DESCRIPTIVE REPORT

Type of Survey Field Examination
Field No. MI-5-1-83
Office No..... FE-253

State Maine
General Locality Approaches to Penobscot Bay
Locality Two Bush Channel

DESCRIPTIVE REPORT
TO ACCOMPANY
SPECIAL INVESTIGATION, TWO BUSH CHANNEL
PENOBSCOT BAY, MAINE
(OPR-A166-MI-83)

PSR# 3023

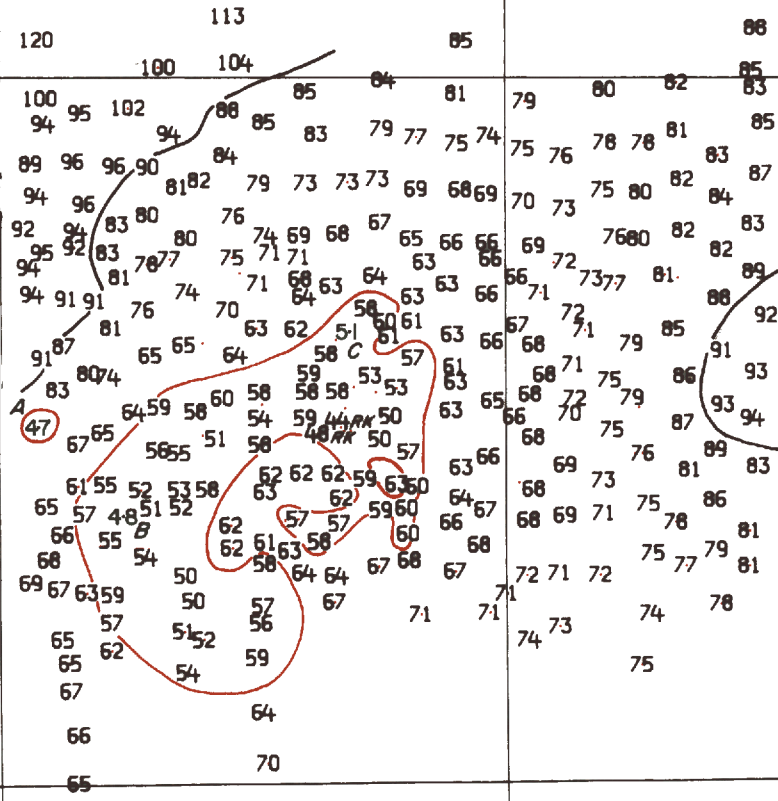
This 38' sounding, charted at Latitude 43°55'22"N, Longitude 69°08'45"W, was developed on J.D. 153 by employing a buoy circle search with a sounding launch. Divers were deployed over the area where the shoalest depth was observed on the fathogram.

Divers obtained a leadline depth over the largest boulder in the area, the most obvious feature in the area, and a simultaneous echo sounder depth was obtained for comparison.

The leadline depth, reduced for ^{smooth} predicted tides, resulted in a least depth of ~~38'~~^{36'} (pos. 600~~X~~³).

It is recommended that the ~~38'~~^{36'Rk} sounding ~~presently~~^{be} charted, remain as such.

PSR# 3025

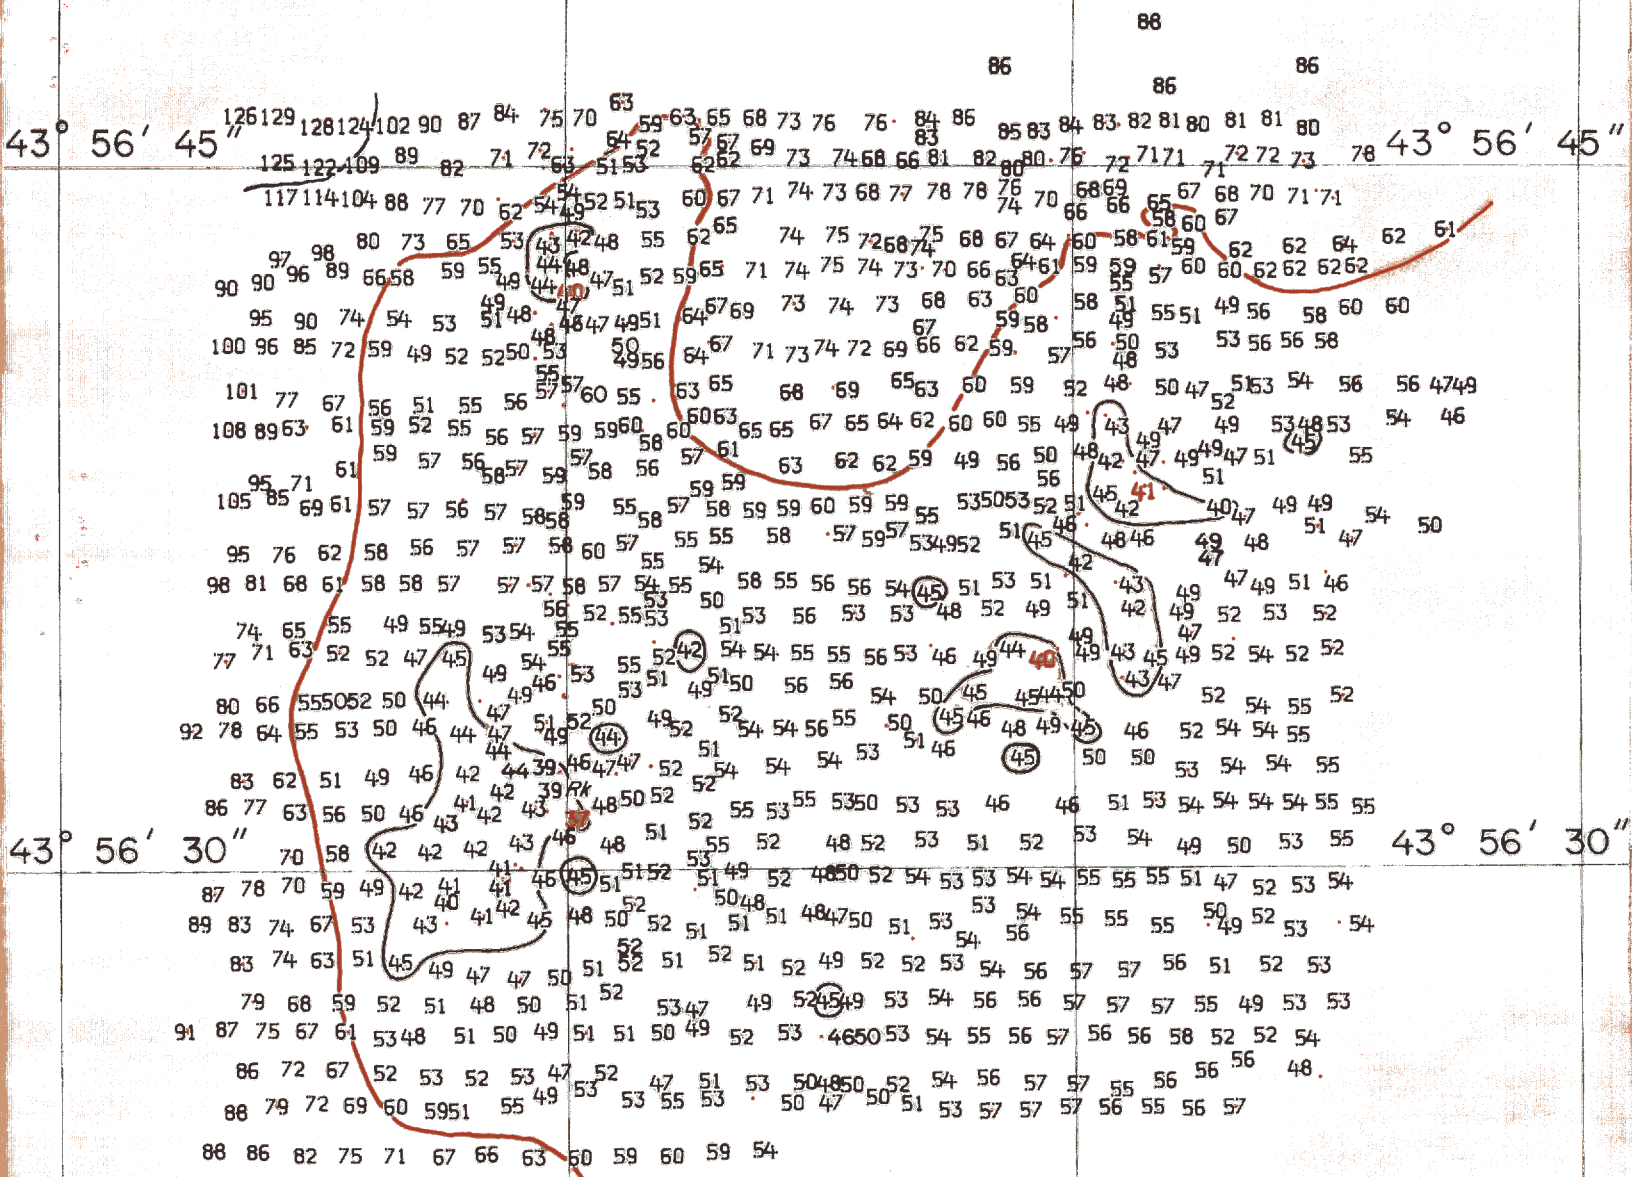
This 49' sounding, charted at Latitude $43^{\circ}56'42''N$, Longitude $69^{\circ}04'41''W$, was developed on J.D. 155 by employing a buoy circle search with a sounding launch. Divers were deployed over the area where the shoalest depth was observed on the fathogram.

Divers obtained a leadline depth over a very prominent pinnacle rock and a simultaneous echosounder depth was obtained for comparison. The leadline depth, reduced for ~~predicted~~ tides, resulted in a least depth of $5\frac{1}{2}$ ' (pos. ~~6004~~ 6019).

The extent of this search is undetermined

It is recommended that since the pinnacle rock was the only feature in the area, the presently charted 49' sounding be retained in the interest of creating a wider margin of safety. — Concur — *The 49' sounding from H-8176 (1954) was brought forward to the smooth sheet.*

~~52 49~~ MARK ← from H-8176 (1954)
